Precinct 15, Altona North

Amendment C88 to the Hobsons Bay Planning Scheme

Urban Design Evidence prepared by Craig Czarny, Hansen Partnership
on behalf of Hobsons Bay Council
November 2017

Lack of information for rhythmic vertical division along Kyle St

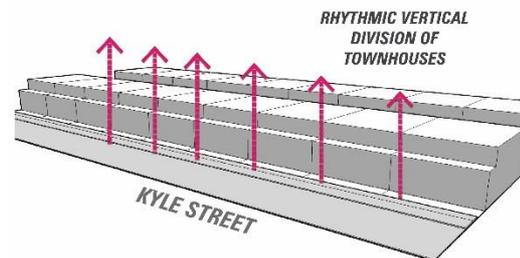
- Local Road frontages** are identified to both Kyle Road to the west and New Street to the east. I support the transitional approach of 2 and 3 storey townhouse and terrace stock to this edge setback 4m behind the frontage.

- Importantly, this format of development is rear loaded (via an accessway or lane). While these parameters are a useful starting framework for this typology, more information is in my view required to guide the presentation of front setbacks (i.e. avoid hardstand or casual parking), rhythmic vertical division of townhouses fronting streets and important relationships with lot depths. In this regard, I note that the identified 'interface' to Kyle Road is much deeper than that illustrated to the east to New Street. I believe that a unified or common interface depth and condition should be applied to permit a generous transition from the site's interior to its edges.

Town Centre Plan – VPA 2017

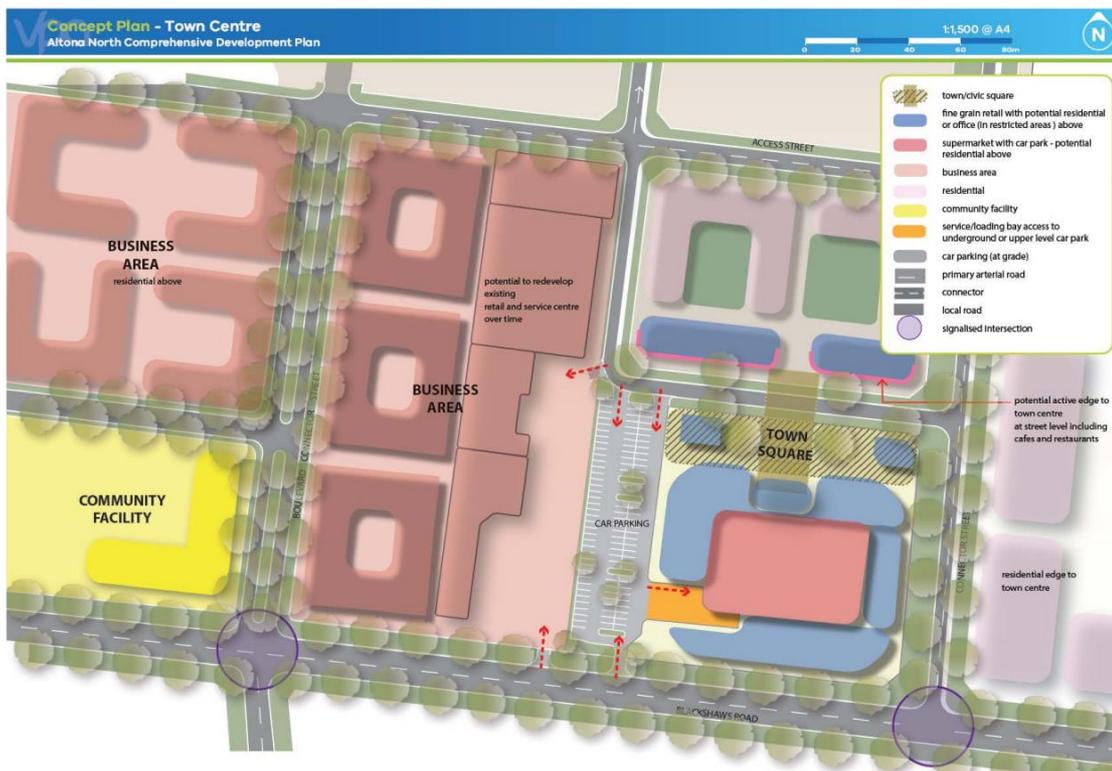
- In contrast to the residential proposition, greater clarity is provided within the CDP for Town Centre, Business Area and Community Facilities on Blackshaws Road as set out in Figure 10 – Altona North Local Town Centre Concept Plan (I note the portrayal of 'block configuration'). This is important given the **integration of proposed development** with the existing Shaws Business Park development which is to be retained insitu. In broad terms, I am satisfied that a 5 storey profile of Town Centre and like development is appropriate, noting the importance of realising an 'intense' urban condition through development that is built to the street frontage with activated ground level and upper level residential form. This is also an apt response for the proposed Community Facility, which can be complemented by walkable linkages and street connections to other activity node destinations along the north side of Blackshaws Road.

- While the internal configuration of the proposed activity node is helpful, **interface management** between remnant functions (the Business Park) and surrounding new residential areas remains ambiguous. I note the rather awkward arrangement between the Shaws Business Park (refer Figure 6- Transitional Commercial Interface) is inconsistent with the Town Centre Concept Plan. I also question the validity of supporting broadscale 6 storey residential forms around the entirety of the Town Centre , whilst limiting the profile of the Centre itself to 5 storeys. These are matters that would be usefully resolved as part of the planning and design process.

Indicative cross-sectional diagram to a depth of 80m to support 2 layers of townhouse stock along Kyle Street

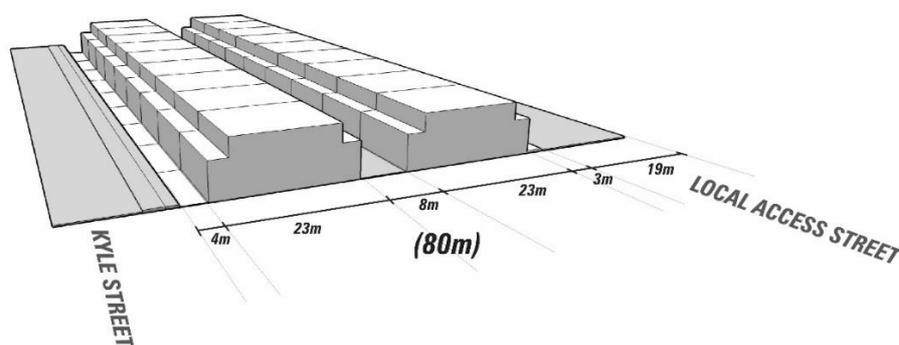
- Some submitters articulated concerns in relation to the location and alignment of **precinct boundaries**, notably Submitter 40 in relation to New Street and Blackshaws Road and Submitter 86 in relation to Kyle Road. I agree that more detailed investigation of property boundary conditions and related precinct alignments are required to ensure a viable development proposition, particularly at the interface. The designated depth of interfaces (to each side) should be commensurate with conventional development envelopes (or a layered arrangement of such) and permit the opportunity for a rear loading via accessway/lane defining a rear boundary. To this end, I would support a common interface depth of 80m to support 2 layers of townhouse stock to the east and west with a single footprint layer of form to Blackshaws Road. I also support a varied interface condition to the Brooklyn Electricity Terminal Station (refer Figure 8) that may offer an alternative landscape buffer with a 'back to back' built response.
